WORKSHOP AGENDA

Planning Commission

September 15, 2026 @ 5:30 PM

For the September 29, 2026 Regular Meeting @ 6:00 PM

Site & Utility Plan

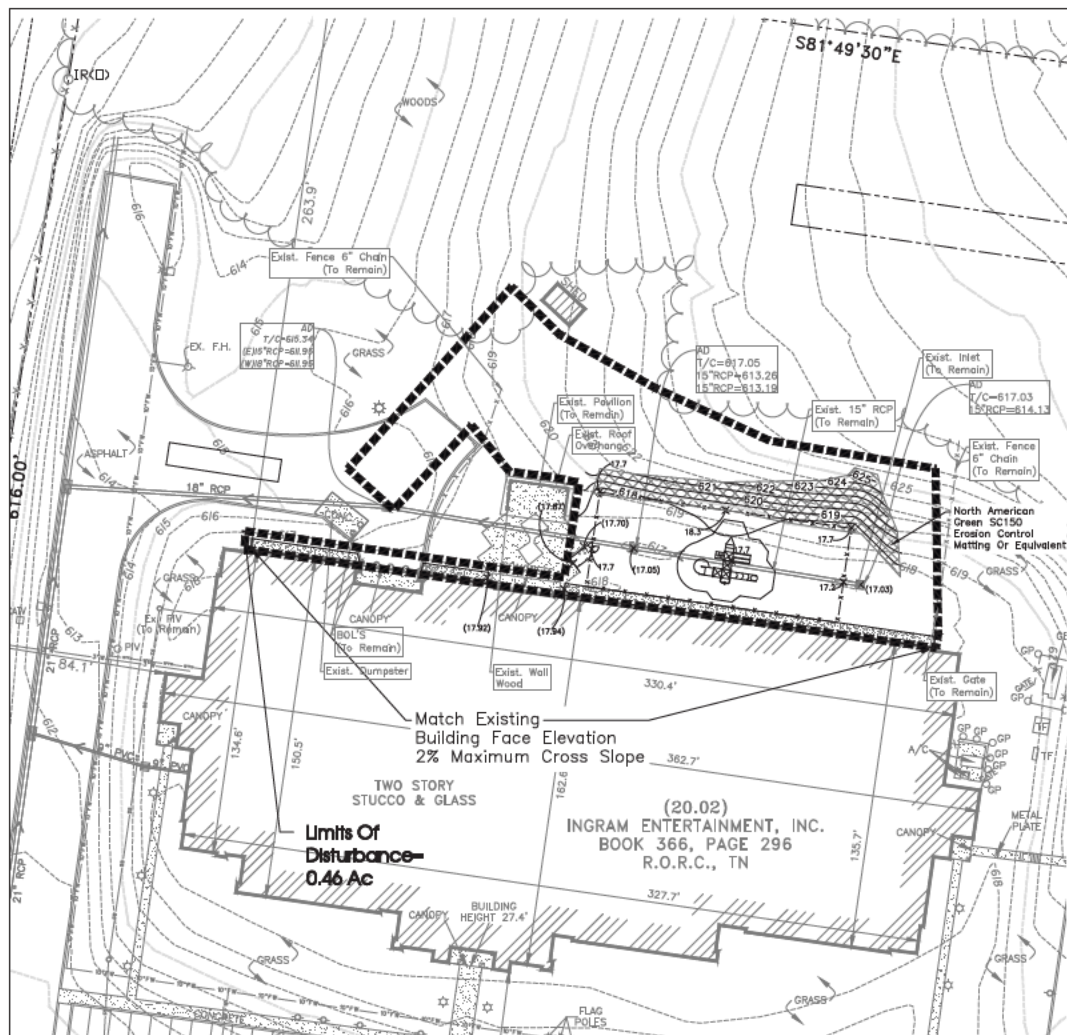
1. Provide a draft LTMA and LTMP fully filled out.
2. Provide bearings and distances around the property.
3. (Sheet C2.0) Provide a city standard commercial entrance ramp as per City Standard Detail C008

4. (Sheet C2.0) Add a dimension which located the building in a north/south direction in addition to the east/west dimension which has already been shown.

6. (Sheet C2.0) Provide dimensions from edge of parking to the property line on the northern boundary and on the northern portion of the eastern boundary.

13. (Sheet C3.0) Provide more detail (spotshots, etc) along Old Nashville Highway between EW@ and EW3.
14. (Sheet C2.0) Show 5' wide sidewalk along Old Nashville Highway and within the public right-of-way.
15. Provide pipe sizing calculations (25-year storm)
